Rezoning Transportation Analysis

Petition Number: 2020-017

General Location Identifier: Tax ID 11101102

Date	Description
03-18-20	First Review

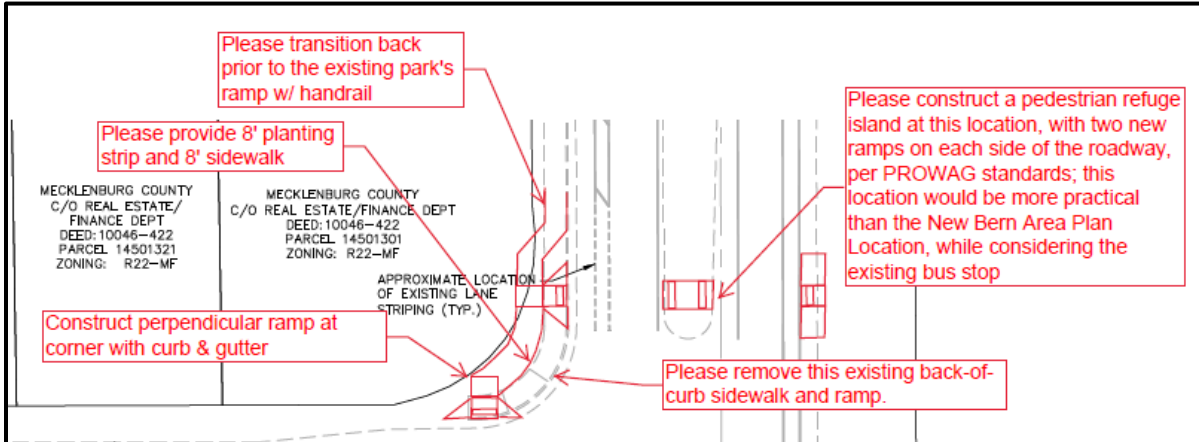
- We request the petitioner to revise the site plan and conditional note(s) to construct a pedestrian refuge island across Remount Road, in reference to the Vision Zero Action Plan and enhanced intersection crossing included within the New Bern Area Plan. CDOT has notified Mecklenburg County of the possibility of the petitioner possibly attaining public utility and construction easements to improve the streetscape at this intersection. Please contact Jacqueline McNeil at (Jacqueline.McNeil@mecklenburgcountync.gov) or (980-314-2511) and Bert Lynn at (Bert.Lynn@mecklenburgcountync.gov) or (704-589-7491). The pedestrian refuge may be unsignalized, but should still include MUTCD pedestrian crossing signage with a marked crosswalk. Please provide CDOT with an exhibit to review.

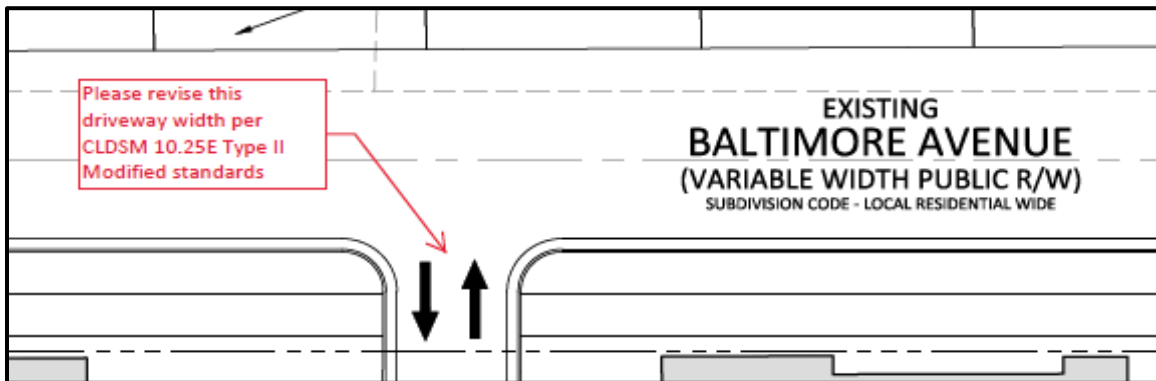
- The petitioner is required to revise the site plan and conditional note(s) to widen the proposed access on Baltimore Avenue to a CLDSM standard for two-way traffic.

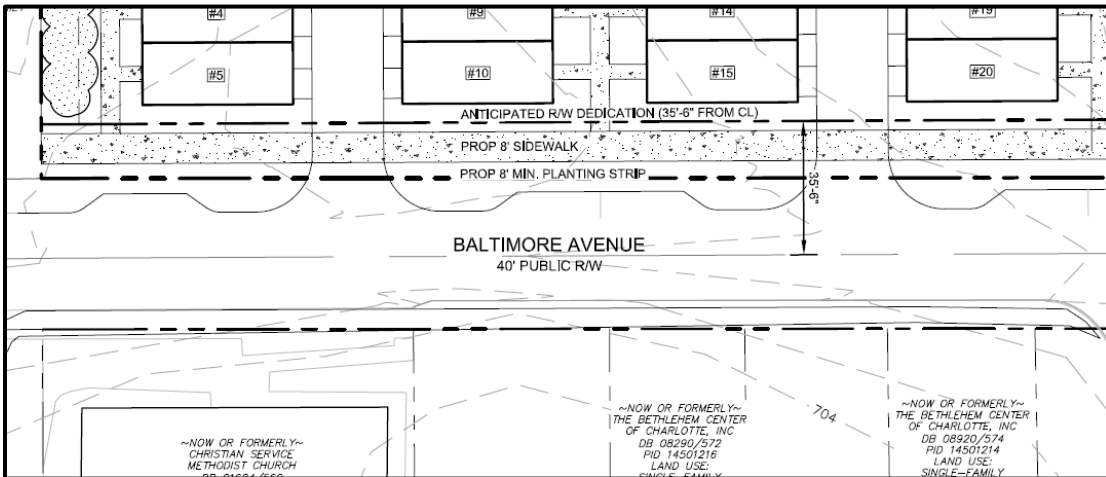
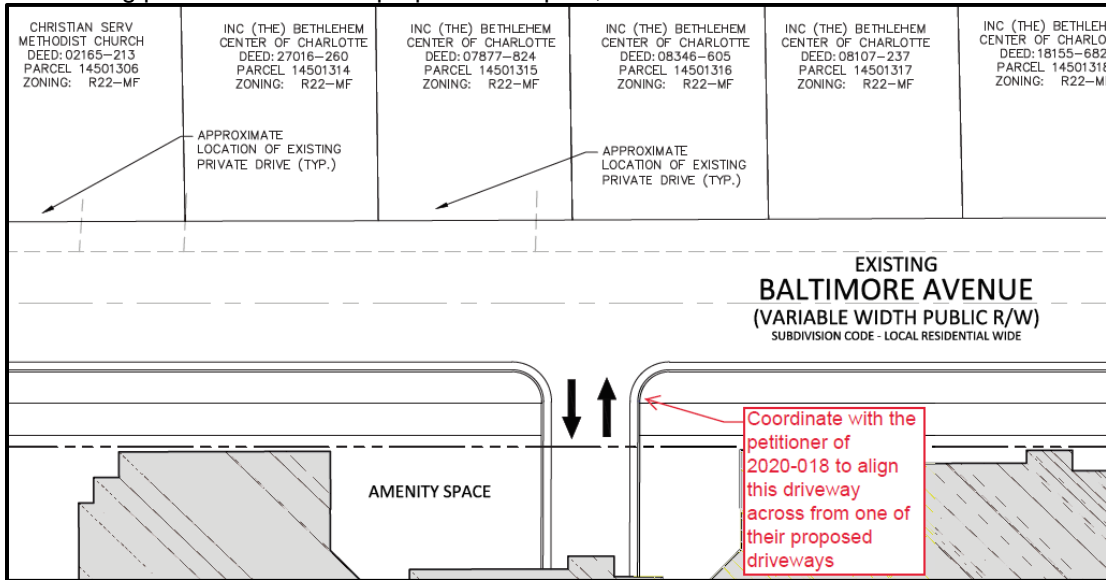
- The petitioner is required to revise the site plan and conditional note(s) to coordinate with the petitioner of 2020-018 to align the proposed access with one of the two proposed driveways with within rezoning petition 2020-018's proposed site plan, or vice versa.

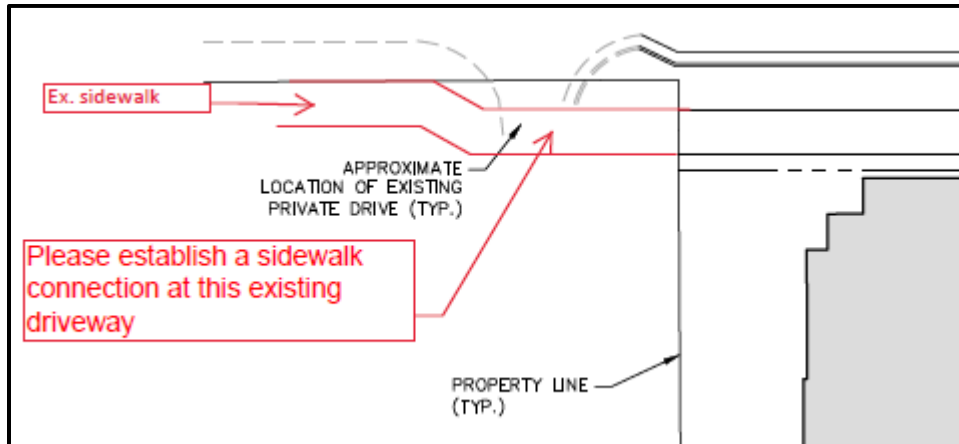
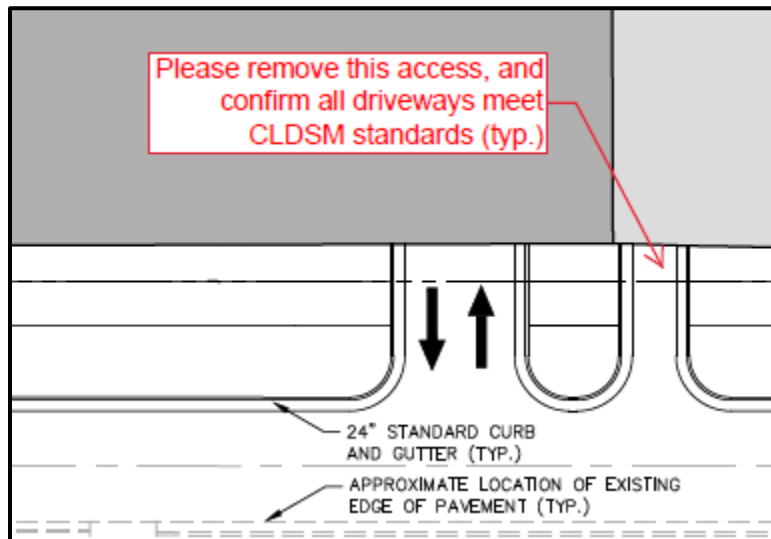
8. The petitioner should revise the site plan and conditional note (Section IV. Transportations, 3) to add specify dedication and fee simple conveyance of **all** rights of way to the City before the site's first building certificate of occupancy is issued. CDOT requests right of way set at 2' behind back of sidewalk where feasible.
9. The petitioner should revise the site plan and conditional note(s) to remove the proposed access on Norfolk Avenue, as shown below.

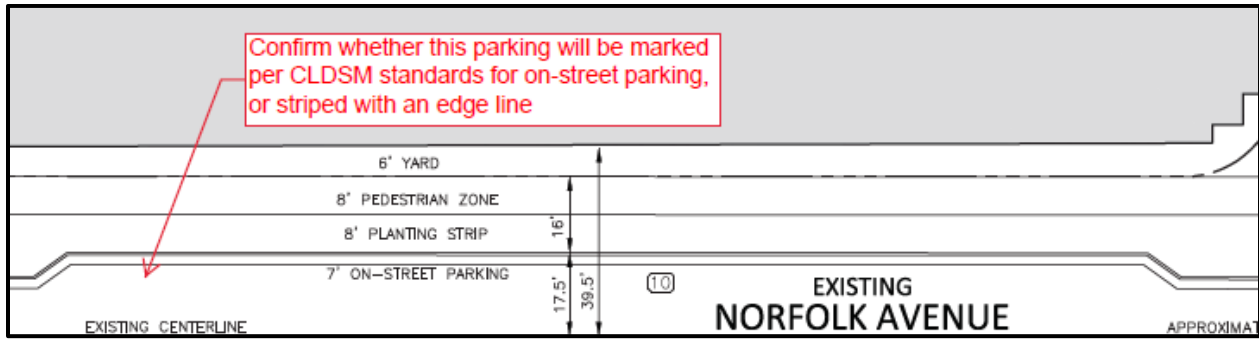
11. In reference to the Charlotte BIKES adopted plan and CDOT Streets Map, CDOT requests the petitioner to revise the site plan and conditional note(s) to restripe the area below to replace the existing eastbound right turn lane in favor of extending the buffered bike lane to the intersection of Tryon Street. This request is also supported to establish a constant bike facility connection to the Rail Trail directly into South End.
